UNITED STATES PATENT AND TRADEMARK OFFICE

APPLICATION NO.	FILING DATE	FIRST NAMED INVENTOR	ATTORNEY DOCKET NO.	CONFIRMATION NO.
09/728,038	12/01/2000	Hung Chen	AMAT/3778/CMP/CMP/RKK	2584
44257 7590 01/03/2011 PATTERSON & SHERIDAN, LLP - - APPM/TX 3040 POST OAK BOULEVARD, SUITE 1500 HOUSTON, TX 77056				
EXAMINER				
GRANT, ALVIN J				
ART UNIT		PAPER NUMBER		
3723				
MAIL DATE		DELIVERY MODE		
01/03/2011		PAPER

Office Action Summary

DETAILED ACTION

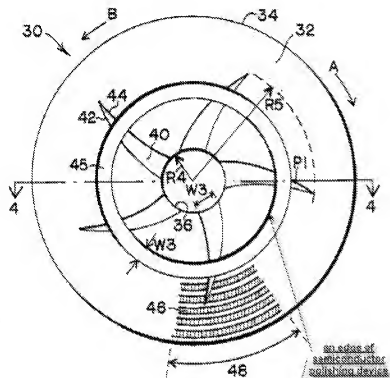
Regarding claims 8 and 42, see drawing below.

semiconductor polishing device to **an edge** of the semiconductor device in not convincing. The figure above discloses this feature.

- Applicant's argument that Burke does not teach a pad having a center is not convincing. The figures above clearly show a center.
- In response to Applicant's argument that extending the channel to **the edge** of Burke's pad would cause the slurry to flow past the wafer and off the pad, Applicant claims recite **an edge** of the pad and this feature is satisfied by Burke.

- In response to Applicant's argument that Burke does not teach *no point on the grooves is tangent to a radial line extending from a center of the substrate polishing pad* as recited in claim 15, Fig. 3 above show that no point on the grooves in question (i.e. 40) would have a tangent extending from the center. The other elements of claim 15 have been addressed above.
